April 26, 1991
LD-91-018

Docket No. 52-002

Subject: Response to NRC Requests for Additional
Information

RESPONSES TO REQUEST FOR ADDITIONAL INFORMATION,
PLANT SYSTEMS BRANCH

FIGURE 440.22-1

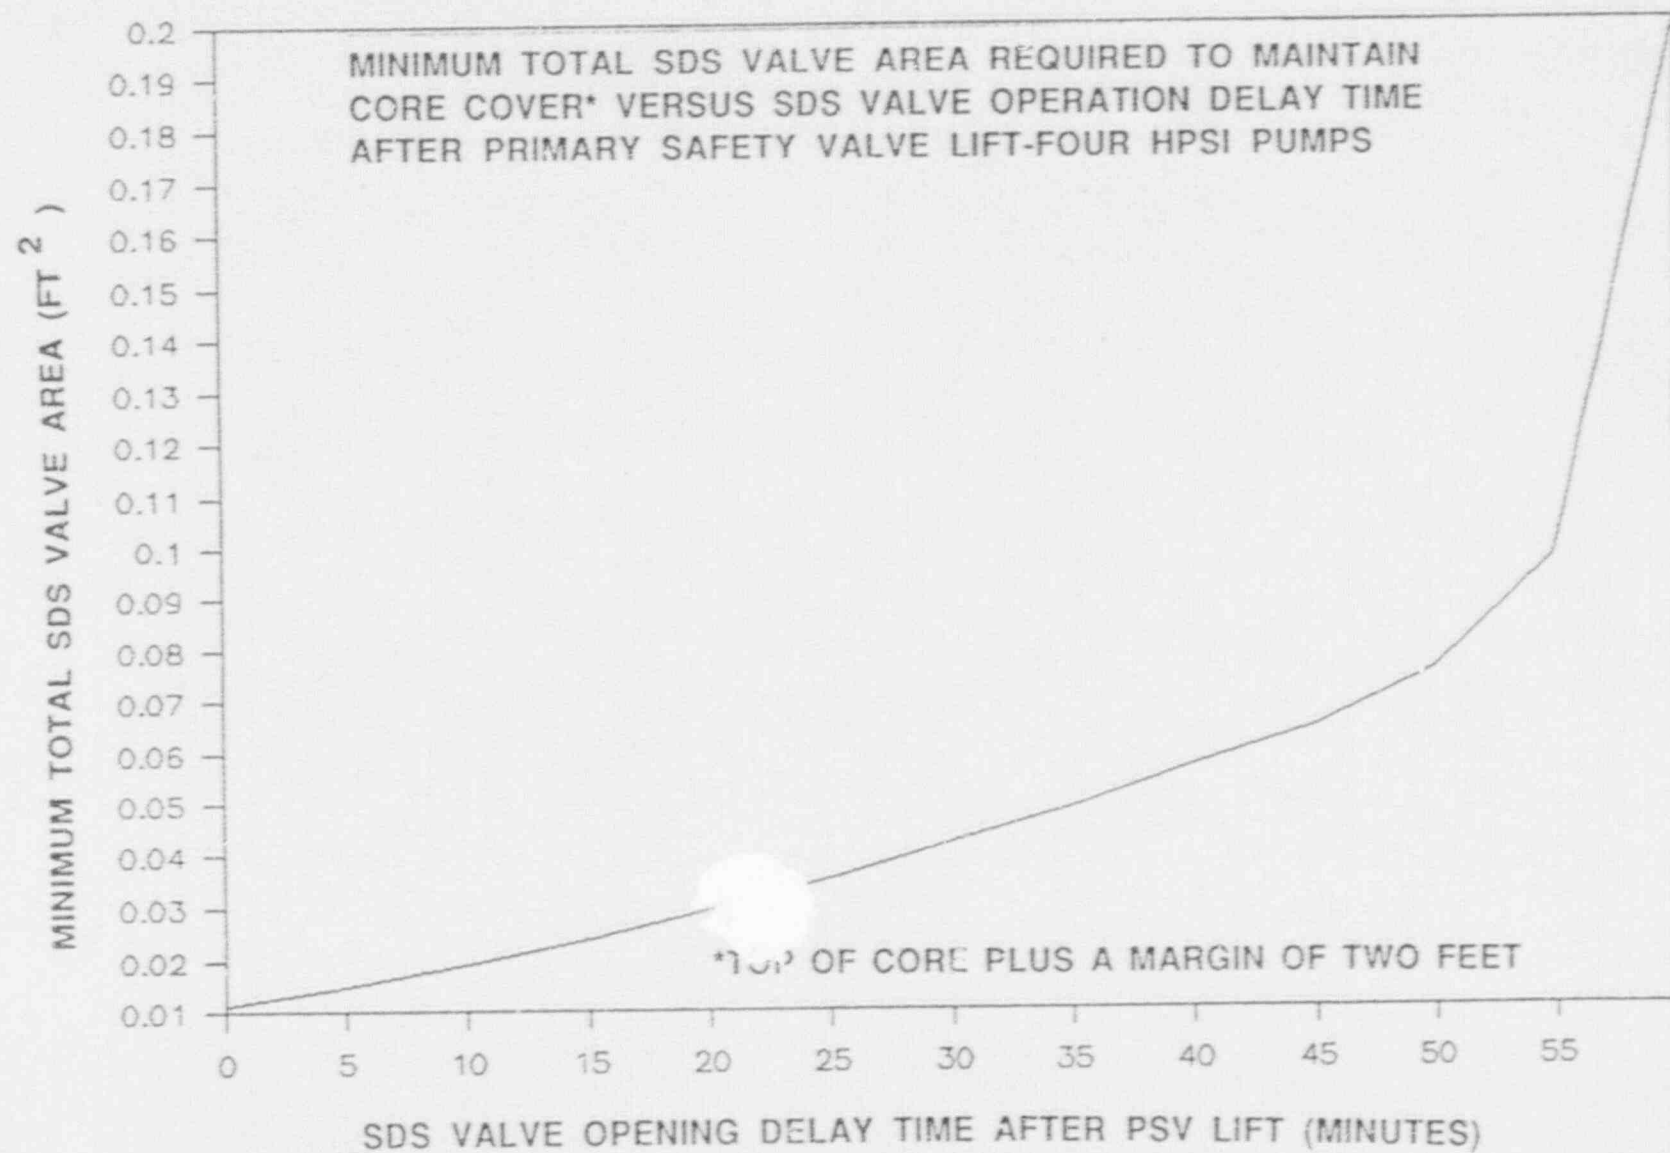
In a letter dated August 28, 1990, you have stated that the initiation of feed and bleed decay heat removal on the System 80+ can be delayed for up to 30 minutes following steam generator dry out. Provide detailed discussion on the subject including the following:

- (a) What were the success criteria for feed and bleed decay heat removal on the System 80+ design?
- (b) Discuss the emergency operating procedure (EOP) developed for feed and bleed decay heat removal to achieve successful operation.
- (c) Provide thermal hydraulic analysis performed based on the plant configuration of the System 80+, to demonstrate that under the most limiting complete loss of secondary heat sink conditions, the success criteria will be met using the EOPs described in item (b).
- (d) What control room indications are used by the operators for a successful feed and bleed operation?

To determine the valve size required to meet the goal in criterion (a) 2, a curve was developed which shows the variation between bleed valve total area and opening time delay after the primary safety valves lift. This curve is shown in Figure 440.22-1. Combustion Engineering chose a valve size which was slightly smaller than the size of a primary safety valve (0.021 square feet per valve versus 0.03 square feet per safety valve). The basis for using a valve size smaller than the PSVs was to ensure that any thermal transient imposed on the RCS during non-accident use would be less severe than that for operation of the PSVs. Two valves of this size allow a delay time up to 30 minutes as indicated in Figure 440.22-1. The dashed curve of Figures 440.22-2 and 440.22-3 represent the pressurizer pressure and reactor vessel mixture level transient, respectively, for this valve size. The solid curve represents the transient response without the feed and bleed operation.
